E4438C-23A

S E R V I C E N O T E

E4438C Vector Signal Generator

Intermittent CPU boot-up and/or No display

Figure 1 U7 location – bottom side of the board.

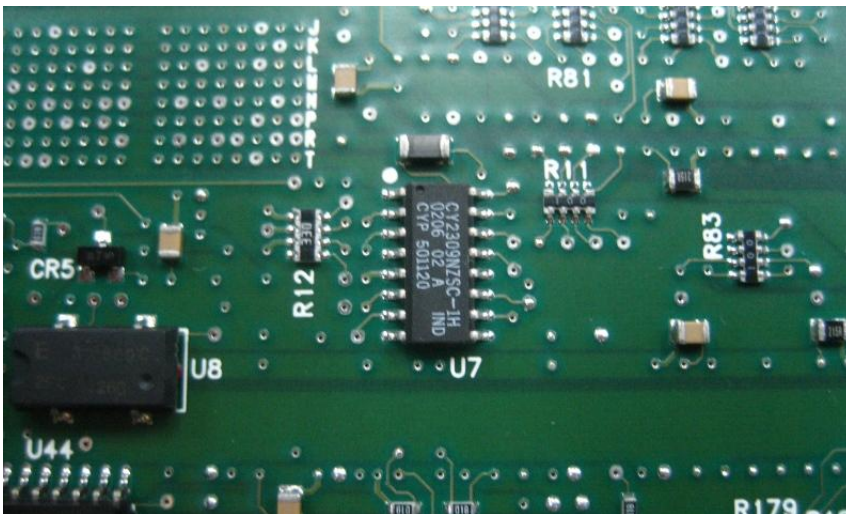
The clock buffer, U7 on the A12 CPU board, part number E4400-60500 may cause intermittent boot up and/or no display when the instrument is powered up. It is recommended that this modification is performed on any instrument within the serial numbers above that exhibits an intermittent boot-up and/or a blank display.

Using the appropriate soldering technique and ESD station, perform a modification on the U7 circuit on the A12 CPU board. Connect U7 pin 8 to 3.4V (wire pin 8 to pin 4) and connect U7 pin 9 to DCOM (wire pin 9 to pin 12).

1. Refer to E4428C/38C Service Guide for the A12 CPU removal procedure.
2. Refer to Figure 1 for U7.
3. Use 30 AWG wire for wiring pin 8 to pin 4, and pin 9 to pin 12 per Figure 2.
4. Re-install CPU and cover.
5. Run self test.
6. No calibration is required.
